DEVELOPMENT APPLICATION ASSESSMENT REPORT

Application Number:	DA2021/2570
----------------------------	-------------

Responsible Officer:	Stephanie Gelder
Land to be developed (Address):	Lot 11 DP 200198, 7 Rounce Avenue FORESTVILLE NSW 2087
Proposed Development:	Alterations and additions to a dwelling house
Zoning:	Warringah LEP2011 - Land zoned R2 Low Density Residential
Development Permissible:	Yes
Existing Use Rights:	No
Consent Authority:	Northern Beaches Council
Land and Environment Court Action:	No
Owner:	Jari Petter Hyvarinen Heather Mary Hyvarinen
Applicant:	Macky Valakas

Figure 1. Rear Boundary encroachment by Deck (highlighted in blue).

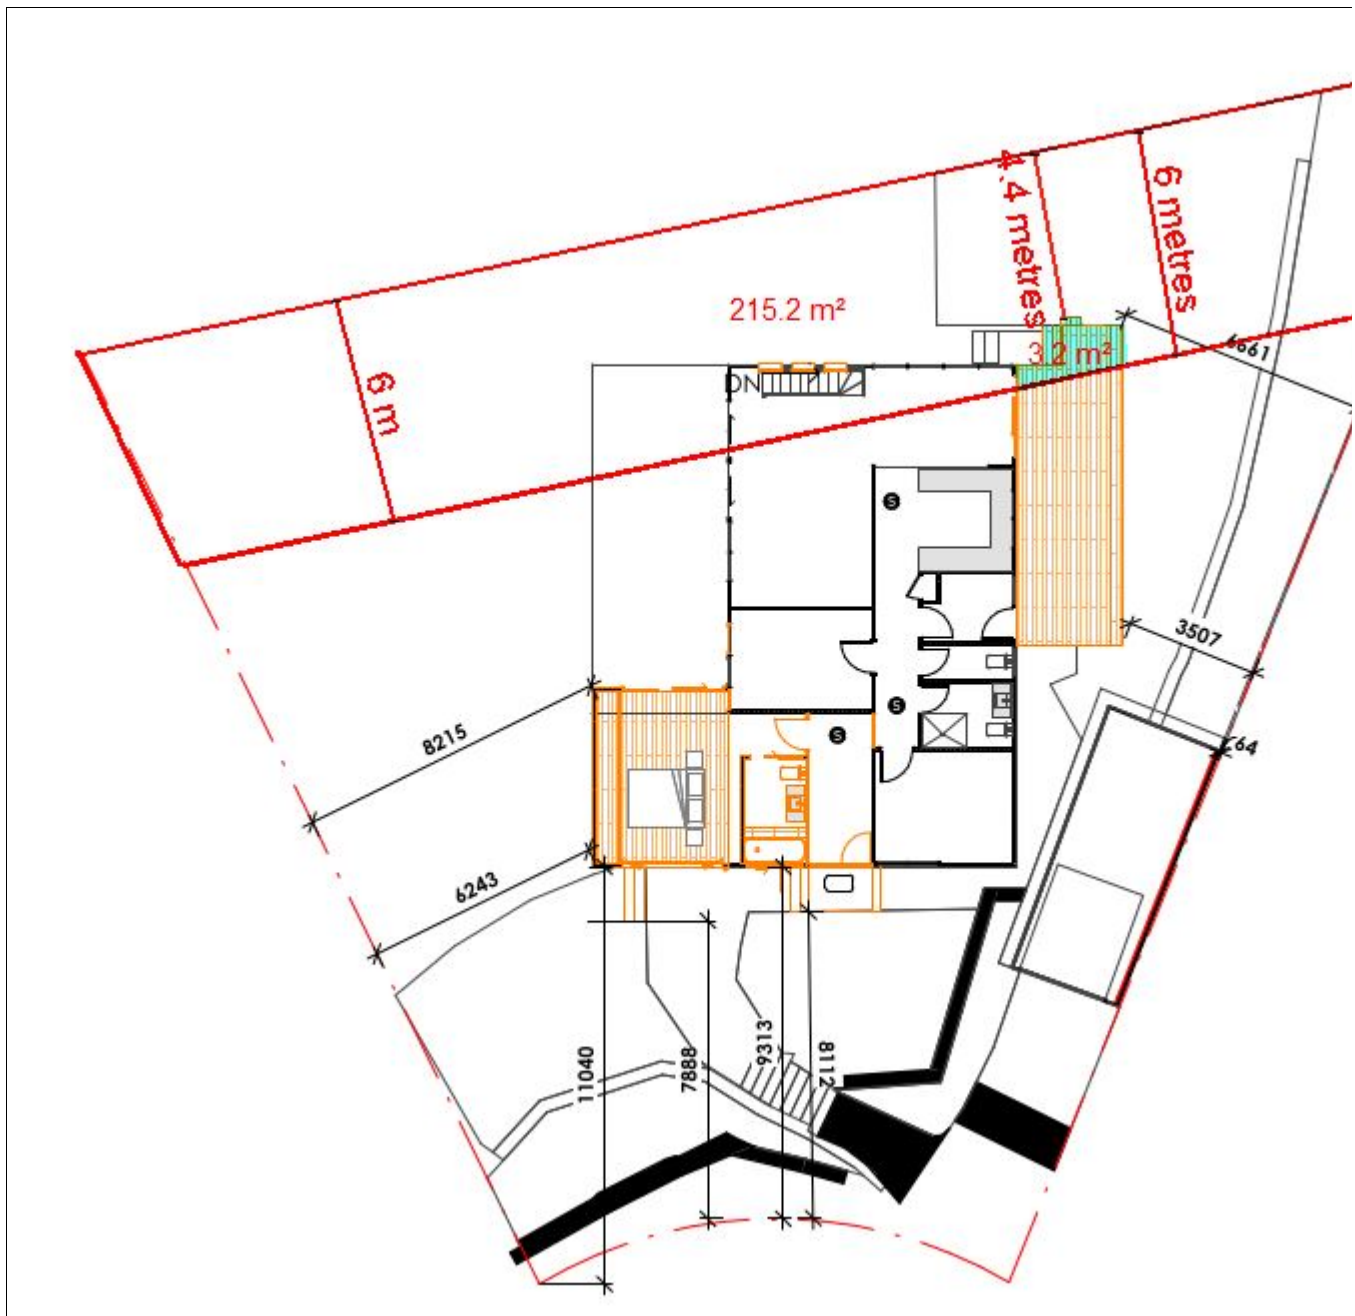
The proposed deck is located 4.4m from the rear boundary line (see Figure 1).

Under Part B9 of the Warringah Development Control Plan exceptions can be made for land zoned R2 Low Density Residential, where the minimum rear building setback is 6 metres, exempt development, swimming pools and outbuildings that, in total, do not exceed 50% of the rear setback area, provided that the objectives of this provision are met.

The deck is considered to be exempt development and in this instance accommodates less than 50% of the rear setback area with an approximate area of 1.48% (3.2m²) of the 215.2m². Therefore, as outlined below, the deck meets the objectives of the control and is supportable in this occasion.
